Customer Service BULLETIN

Customer Service Bulletin 000018932

Title Package update LDX Series and XCU (3G and 10G Universe)

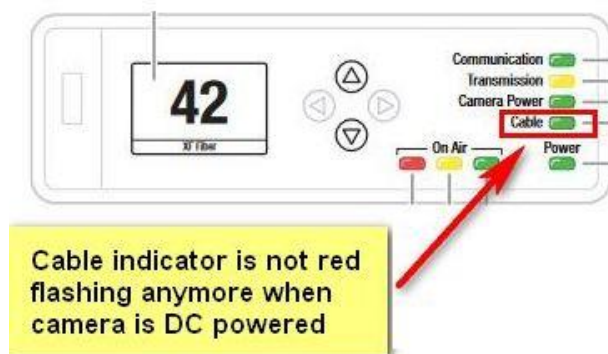
- Horizontal and/or vertical Image flip in 4K (LDX86N only) enabled
- When the auto iris area indicators are selected (Production set-up > Exposure > Iris > Auto Iris > Area Indicator) the indicators will become available at the Mon Output signal of the XCU.

Changed functionality:

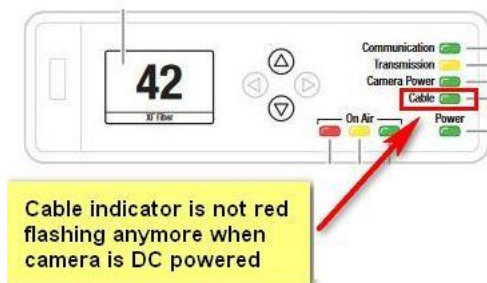
- Add system Alias to cradle storage.
- In case the camera is DC powered (Power box or in Direct IP mode) the cable indicator on the front panel of the XCU is not red flashing anymore as soon as transmission is established
